Re: In re Application of Howard B. Dolgoff  
File No. BPH-911223ME  
Channel 292A, Miramar Beach, Florida

COMMENTS IN REPLY TO  
OPPOSITION TO PETITION TO DENY  
THE APPLICATION BY  
HOWARD B. DOLGOFF  
NEW FM RADIO STATION  
MIRAMAR BEACH, FLORIDA  
JULY 1992

Technical Exhibit  
TE-1

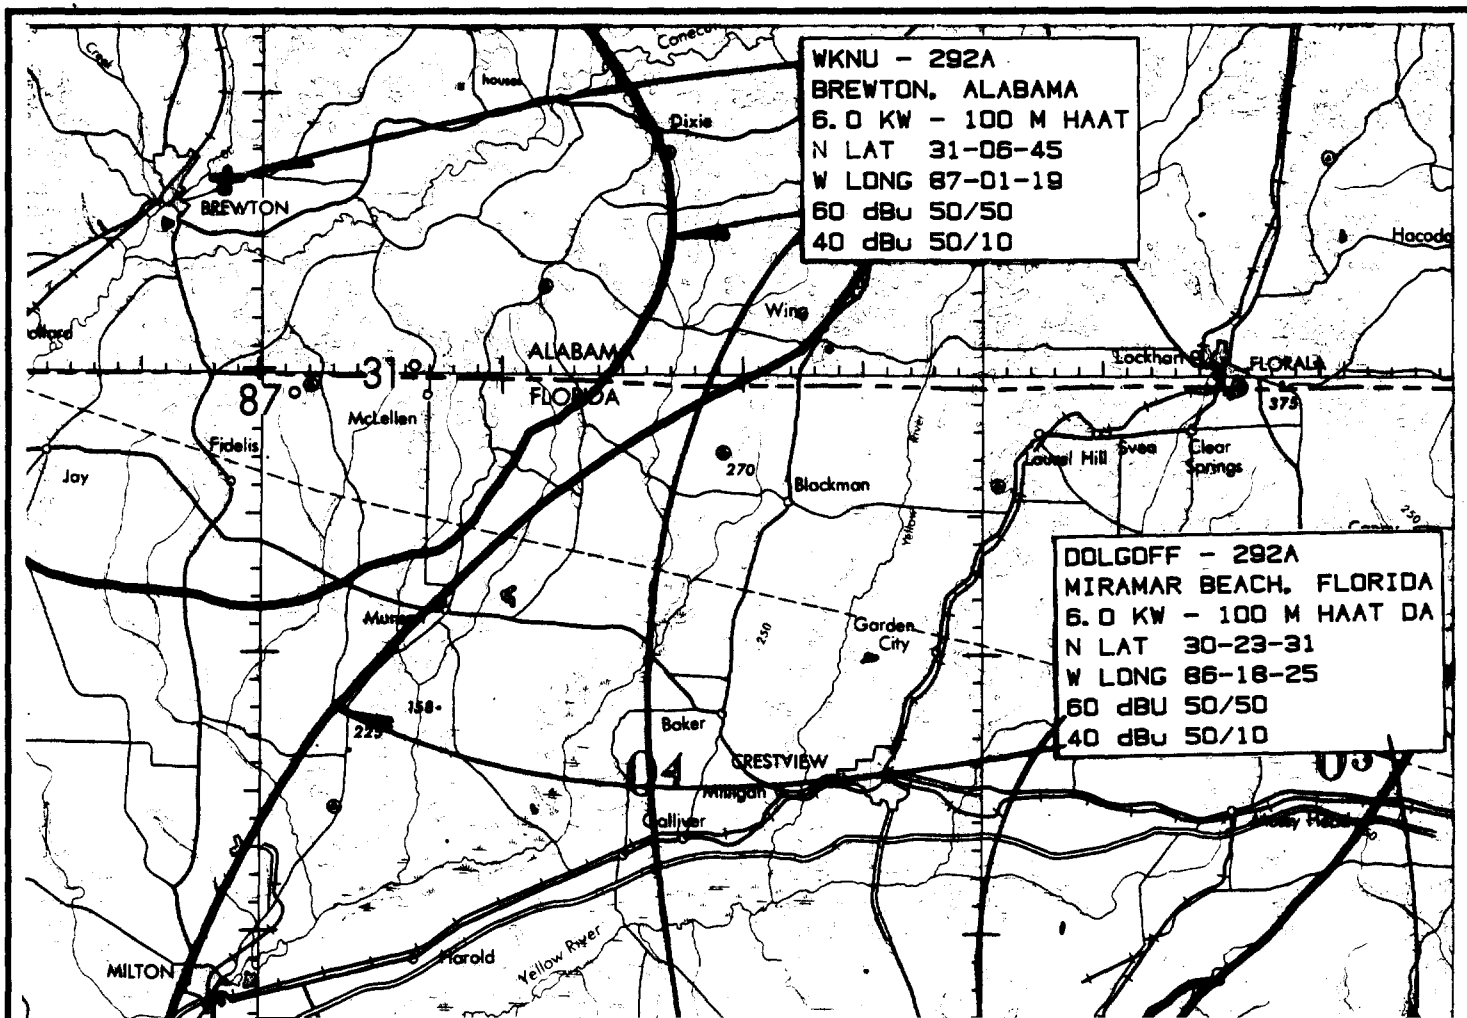
Dolgoff proposes greater than 3 kW at 100 m HAAT service. In employing the contour protection requirements of §73.215 of the Commission's Rules, Dolgoff must assume WKNU as operating with a full 6.0 kW 100 meters height above average terrain Class A station. When Dolgoff's protected (60 dBu) and interfering (40 dBu) contours are projected, with WKNU operating as a maximum Class A facility, there is prohibited overlap of contours between the facilities. Exhibit #1 is a map demonstrating that Dolgoff's proposal would be subject to extensive interference contrary to §73.215 and is therefore unacceptable. Exhibits #2 and #3 are tabulations of the contour calculations used preparation of the map. Exhibit #4 is a tabulation of the Dolgoff and WKNU contours in a form similar to "FMOVER" also demonstrating prohibitive overlap.
